# Flood Zone 3 Advisory Board Meeting

January 13, 2026

Response to Comments

The Initial Study/Mitigated Negative Declaration (IS/MND) for the Marin City Pond Pump Station Flood Reduction Project (Project) was prepared in compliance with the requirements of the California Environmental Quality Act (CEQA). The 30-day public circulation period for the Draft IS/MND started Thursday, May 15, 2025 and was extended by one week to end on Monday, June, 23, 2025. The following pages contain responses to comments submitted by agencies, organizations, and individuals during the IS/MND public review period. Copies of the comment letters are attached to this document in Appendix A.

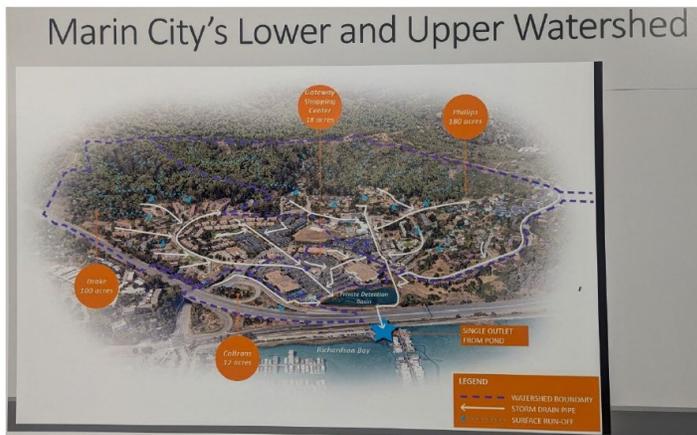
**Comment L.2:** Basis for Pump Station Project?

The Initial Study for the permanent Pump Station also does not provide any real discussion of the basis for the Pump Station project, other than conclusory statements that the Pump Station project "is needed to provide a permanent solution to reduce flooding in Marin City and to maximize the limited conveyance capacity across US 101." However, if the goal is to increase conveyance, it is worth noting that the Second Culvert project would double the "limited conveyance capacity across US 101," by installing a second 6' x 4' culvert parallel to and north of the existing culvert that is proposed to be attached to the proposed Permanent Pump Station.
